Replacement of Fisher™ POSI-SEAL™ A31D Valve with Fisher 8580 & 8532 High-Performance Butterfly Valves

Management of Change

Background

Figure 1. Fisher POSI-SEAL A31D

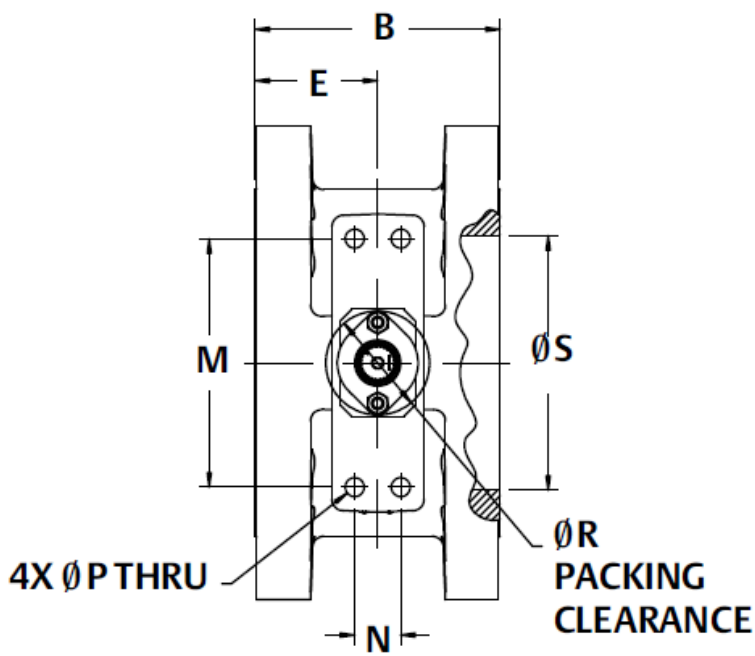
The NPS 3 - 12 A31D has slightly different mounting dimensions than the 8580

The NPS 14 - 24 A31D has the same mounting dimensions as the 8532.
